Wednesday, August 12, 2026

Architectural Review Committee

AGENDA

TOWN OF BROOKFIELD
ARCHITECTURAL REVIEW COMMITTEE MINUTES
MAY 13, 2026

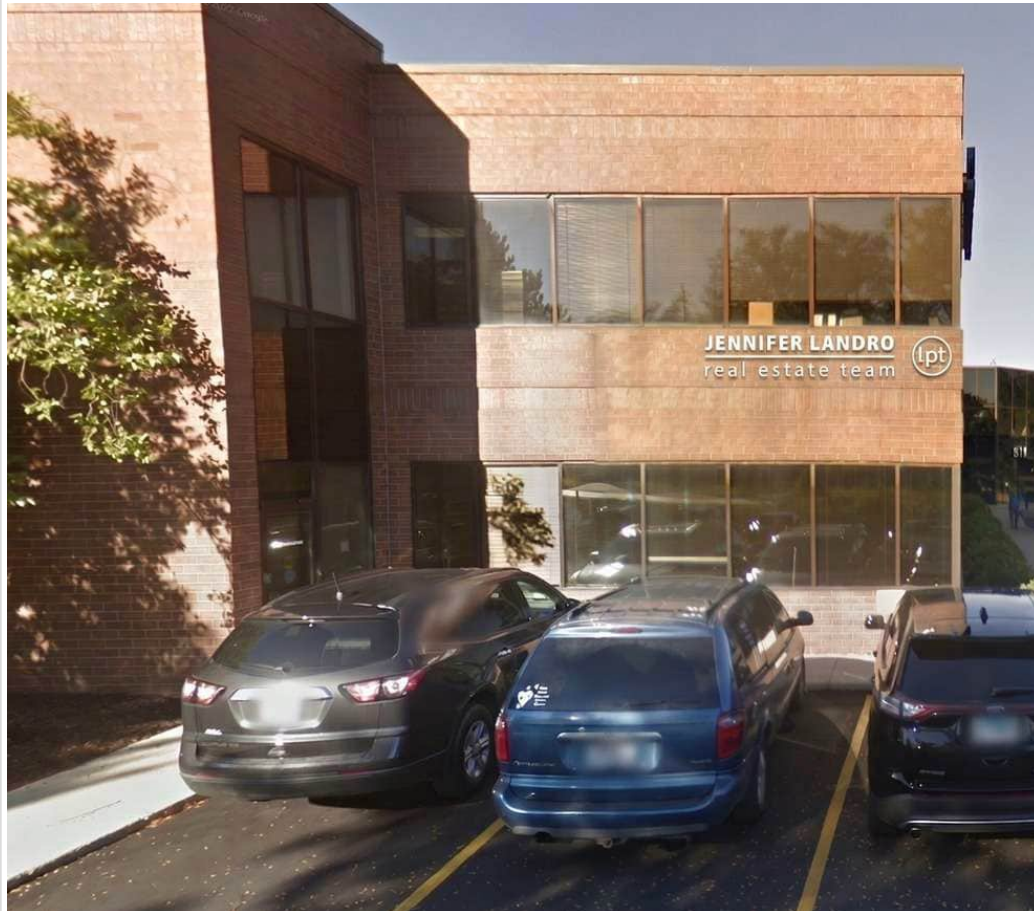
Landro Real Estate is a new tenant in the multi-tenant office building at 601 N. Barker Road, on the east side of the building with frontage on Barker Road. The applicant is requesting two wall signs, one for the east elevation and one for the north elevation that faces Watertown Road. The sign locations are the same as the previous tenant. The proposed signs consist of dimensional cream-colored letters that are mounted flush to the building wall and are non-illuminated. The proposed sign information is as follows:

Proposed	Max. Permitted	Waiver required?
East Elevation	11 ft. x 1 ft. 7 in. (17.3 SF)	112 SF per 140 linear ft. of frontage	No
North Elevation	11 ft. x 1 ft. 7 in. (17.3 SF)	54 SF per 68 linear ft. of frontage	No
# of signs	2	Max. 2 for office buildings	No

The proposed sign meets the Ordinance requirements and no waivers are required.

Johnson Financial Group - Brookfield

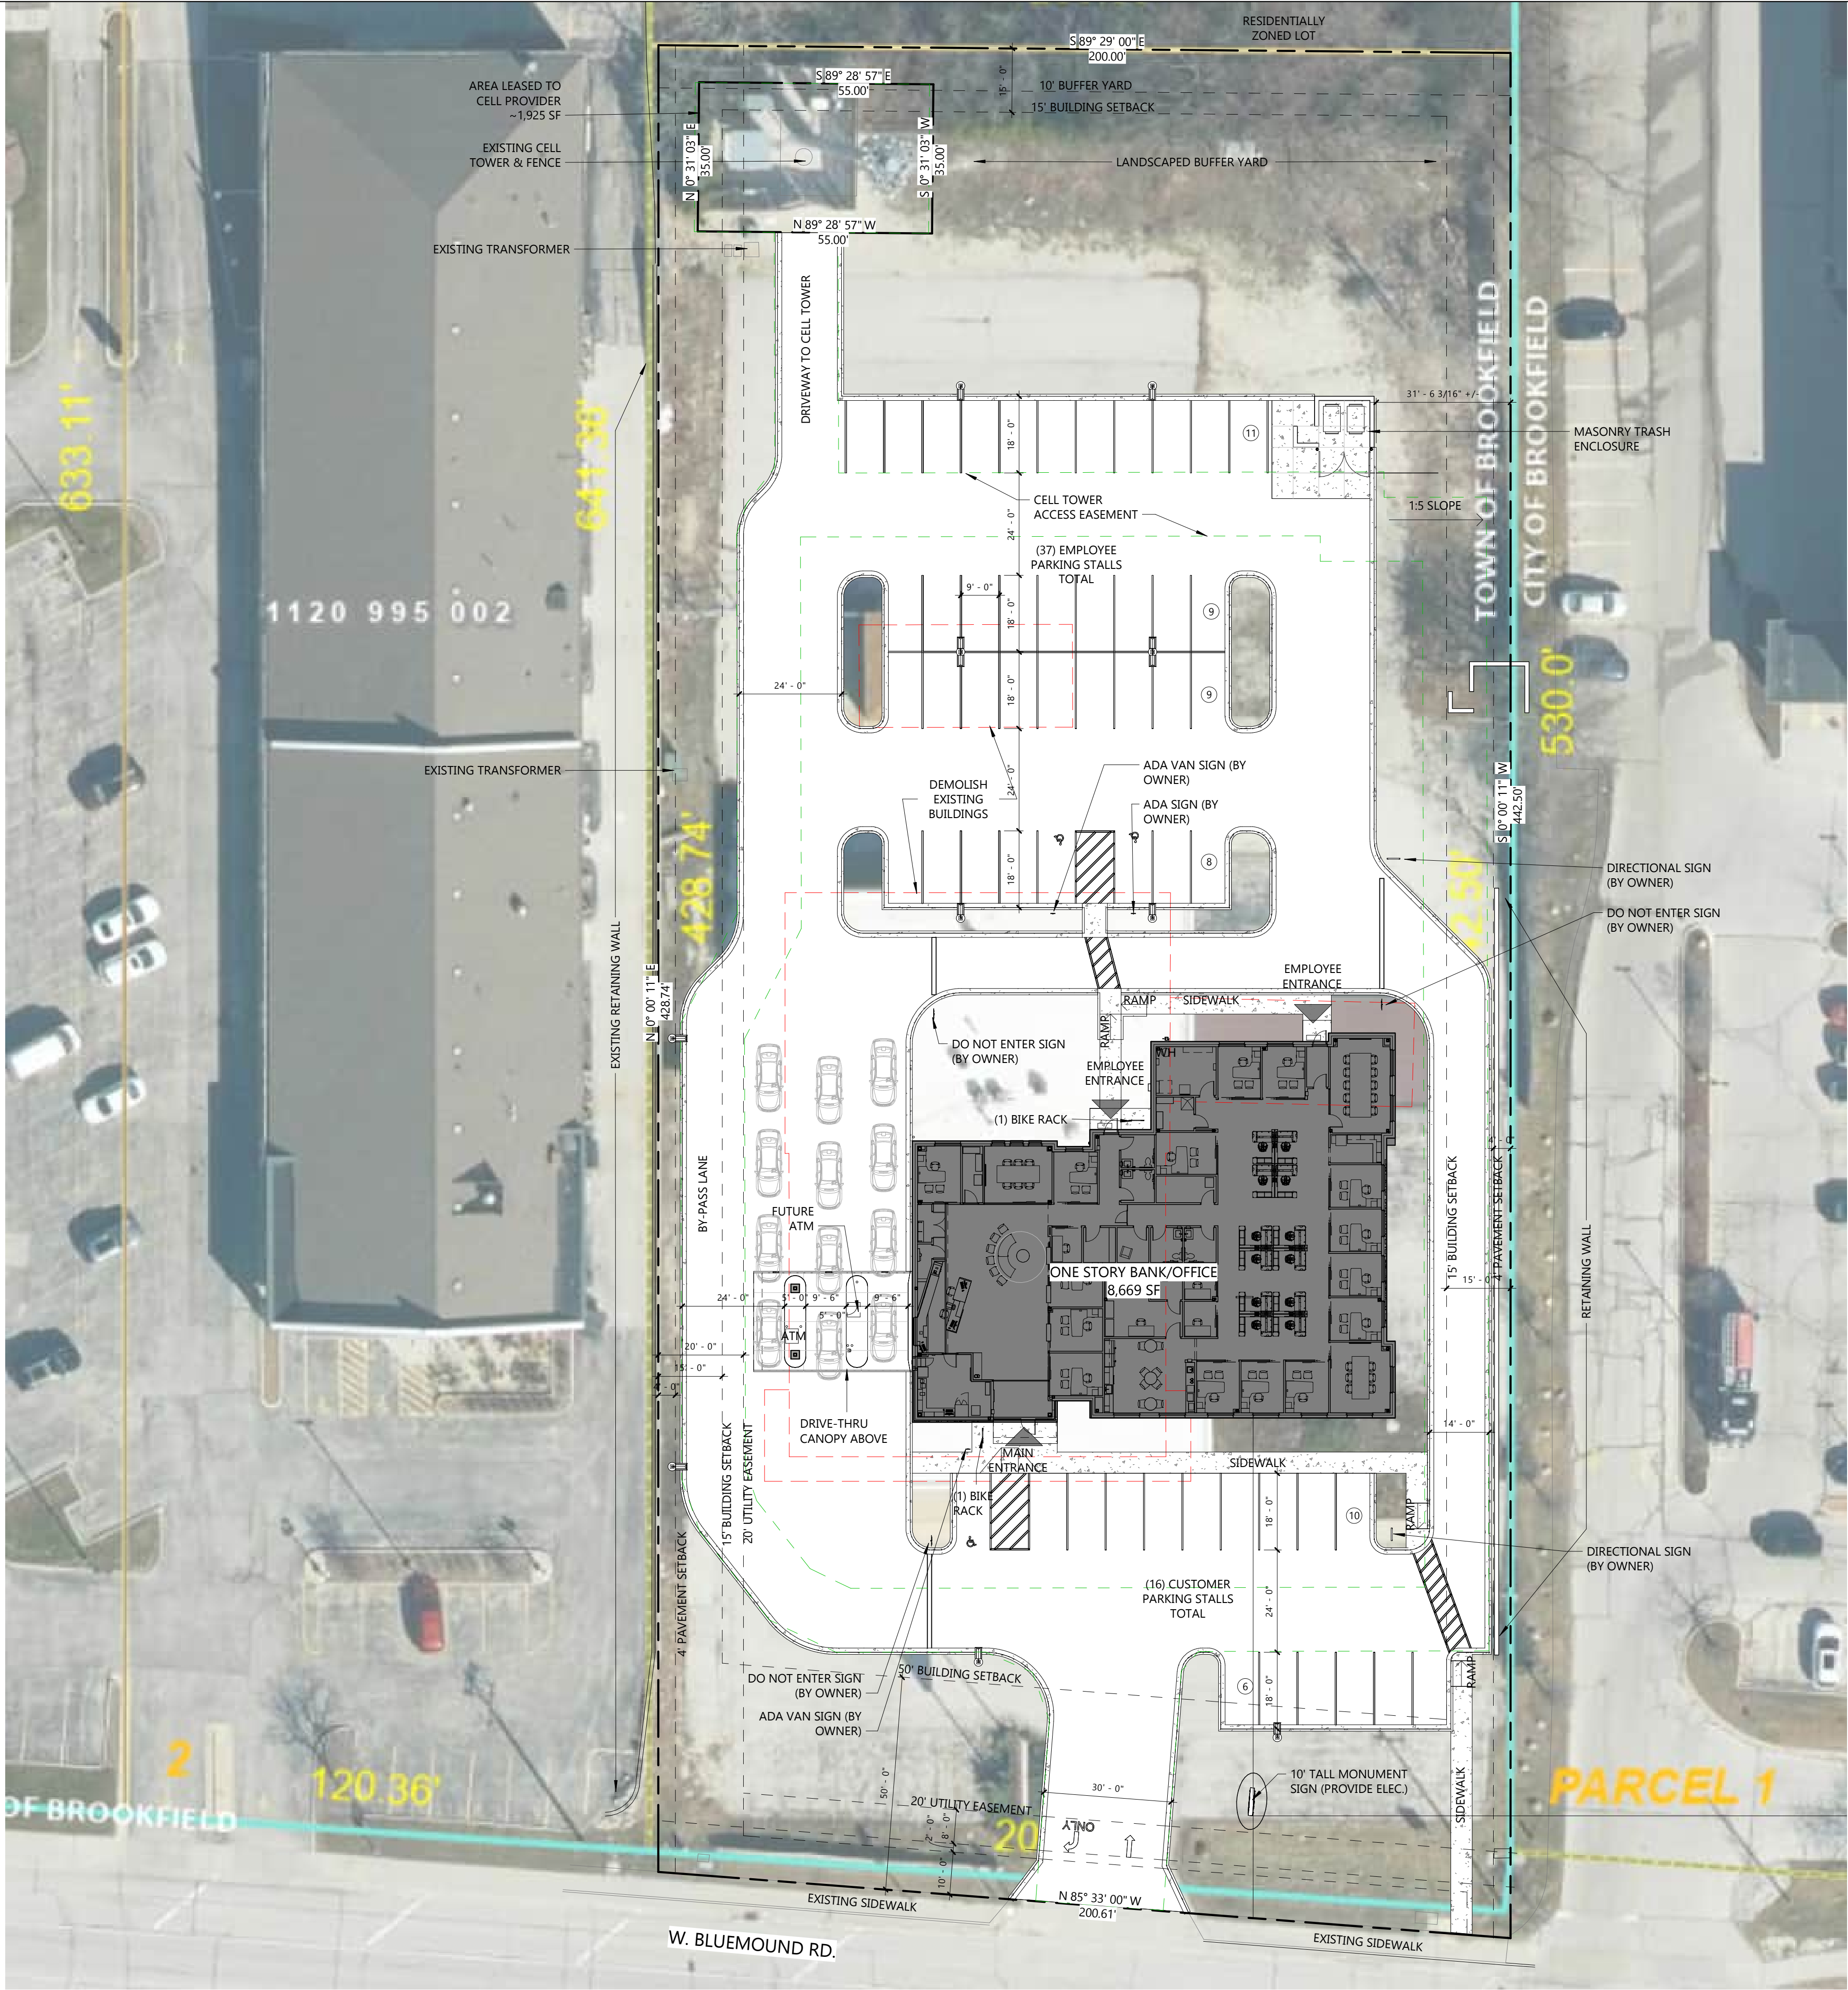
Architectural Plans: The proposed one-story building is 8,669 sq. ft. The building is more modern, with a flat roof and metal canopy. Materials include modular brick veneer, blended stone veneer, aluminum composite metal panels, faux wood aluminum siding, cast stone sill. The combined materials give the building an overall look of brick and wood, with a Lannon stone base and metal accents.

1. Revised sign plans must be submitted that meet the sign code, unless waivers are approved by the ARC for letter height and sign size on the east elevation.
2. A revised landscaping plan that incorporates the additional recommendations prepared by the Town Engineer shall be submitted for Plan Commission review.

The submitted plans require very minor adjustments that can be reviewed internally. The redevelopment of this parcel removes a blighted property from a highly visible location and provides a location for a long-standing business of the area. As submitted, the proposal meets the purpose and intent of the ordinance.
